SERVICE AND APPLICATION NOTES

ACC-16-03
March 3, 2016

Equipment Interface Module (10T50) and Outdoor Air Sensor (X2658)

Figure 1. Equipment Interface Module (EIM) Outdoor Air Sensor Terminals

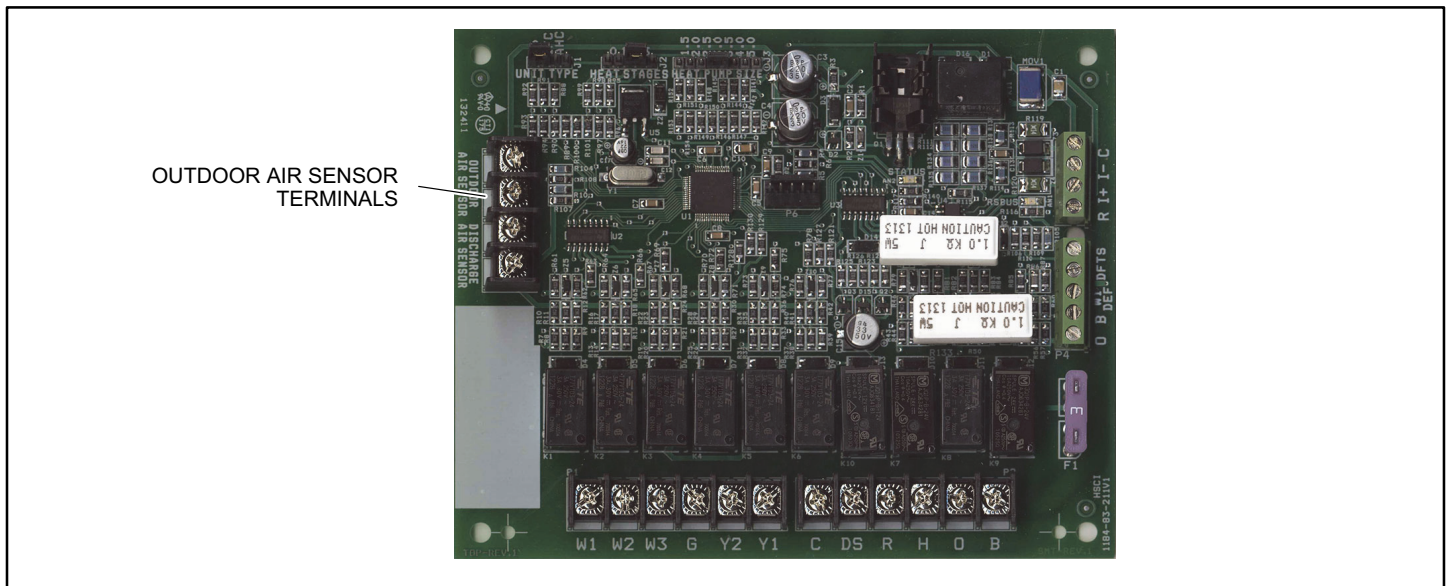
We have had field reports that the Outdoor Air Sensor when used with the Equipment Interface Module may give false temperature readings during times of low outdoor temperatures.

Root cause for issue has been found to be the wrong resistance curve chart used in the EIM software.
